# Record of Appeal for Public Space Permit for 701 10<sup>th</sup> St NE

**MEMORANDUM OF APPEAL**

**Re: Application for public space permit at 701 10<sup>th</sup> St., NE**

**Exhibit A**

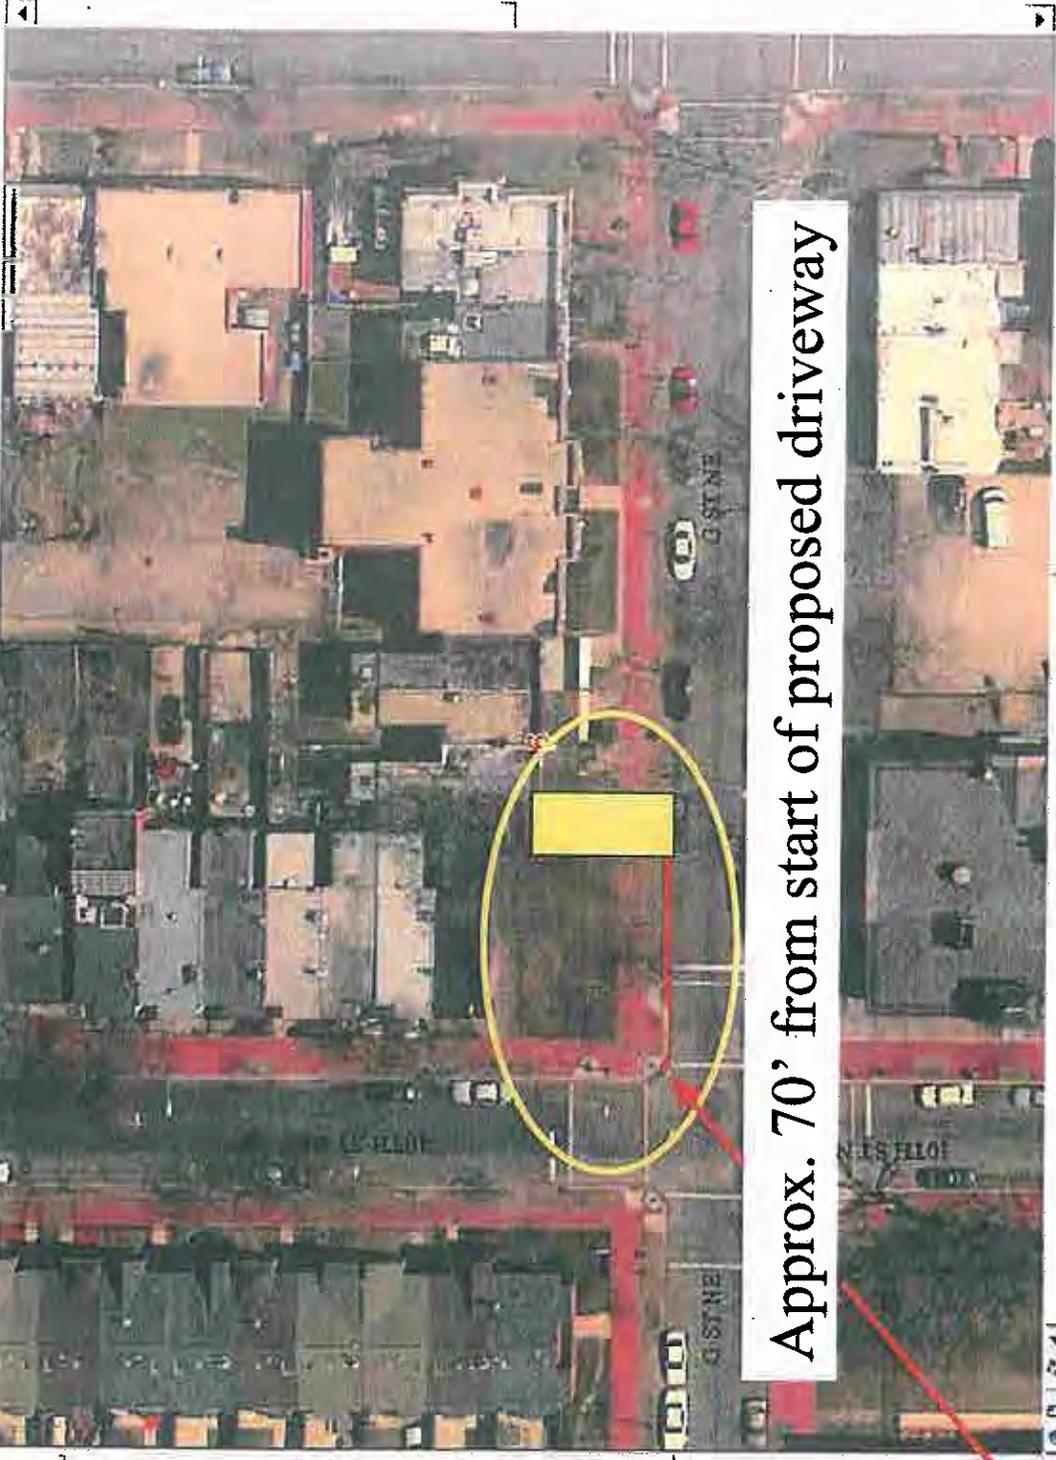
DDOT granted the Permit on the basis of incorrect measurements. All but one of the distance measurements in the administrative record were apparently taken on-site. Inexplicably, the only measurement for which DDOT relied on estimates from an electronic database instead of on-site measurements was the one for the distance from 10<sup>th</sup> Street, NE, to the edge of the proposed driveway. On the basis of this electronic estimate, DDOT concluded that the 10<sup>th</sup> Street, NE, intersection was “Approx. 70’ from start of proposed driveway.”<sup>1</sup>

DDOT’s electronic estimate is grossly incorrect. The Contractor’s own Surveyor’s Plat shows that a 24-foot wide driveway will be somewhere between 30 ft. 11 in. and 47 ft. 8 in. from the intersection.<sup>2</sup> The actual measured physical distance from the intersection to the edge of the permitted driveway is, at most, 57 feet.<sup>3</sup> In either case, the distance from the intersection to the

Approx. 70' from start of proposed driveway

**Exhibit C**

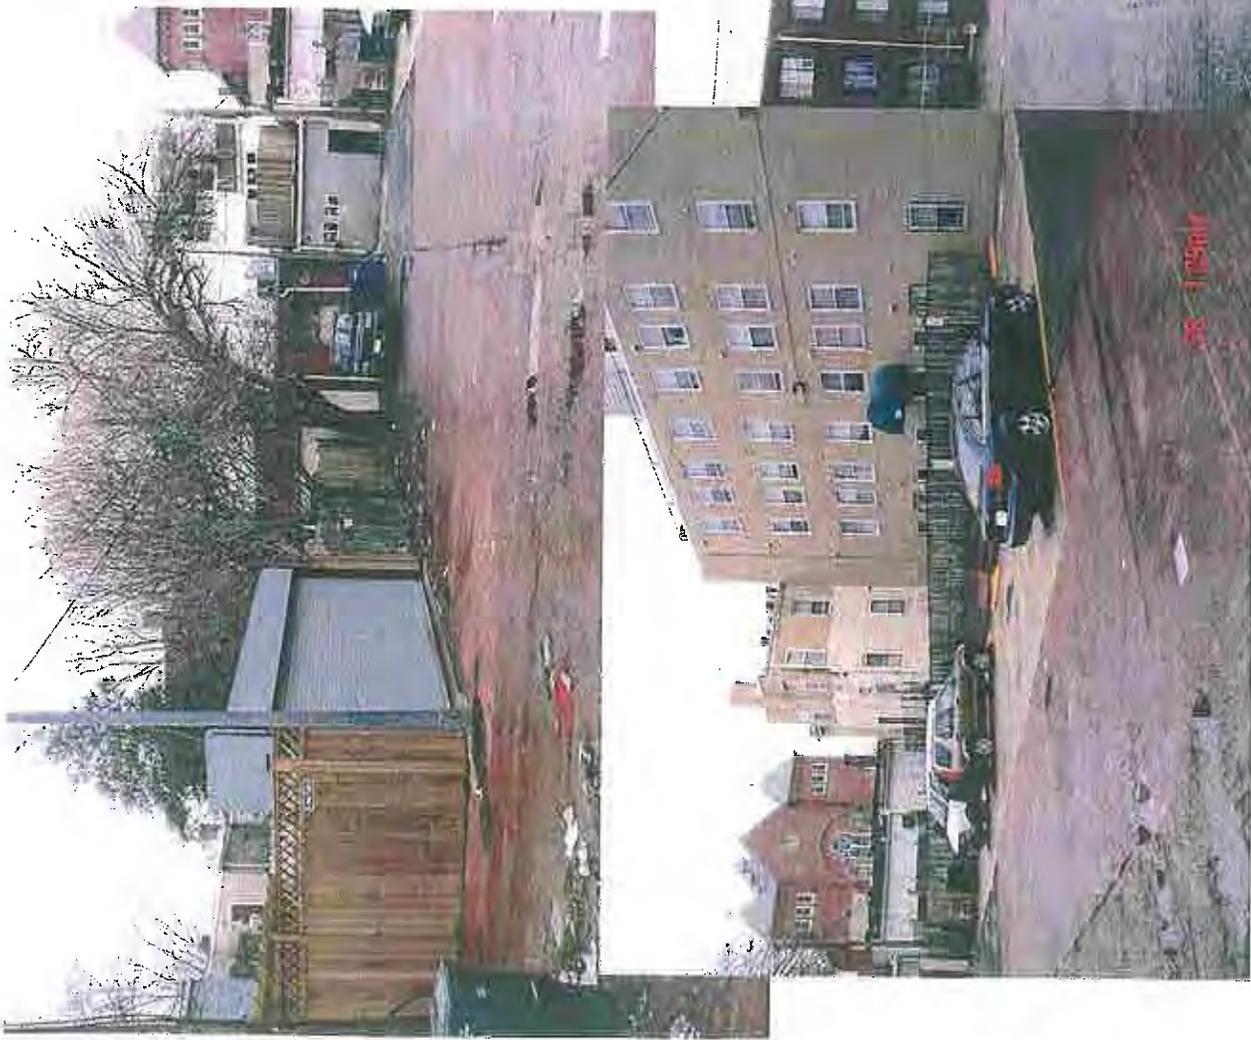
Also, DDOT granted the Permit on the basis of incorrect information about the uniqueness of the Property. Specifically, DDOT stated that the Property's lack of alley access was a basis for granting the permit.<sup>4</sup> The administrative record states that "Everyone else has access to off street parking through the alley but not 701 10<sup>th</sup> St., NE."<sup>5</sup> However, this assertion is entirely wrong. The lack of alley access is not unique to the Property. In the same block as the Property, ten (10) lots lack alley access.<sup>6</sup> The lack of alley access is not a unique feature, so it should not be a reason for granting the Permit.

This is what the alley looks like on that square. Everyone else has access to off street parking through the alley but not 701 10<sup>th</sup> Street.
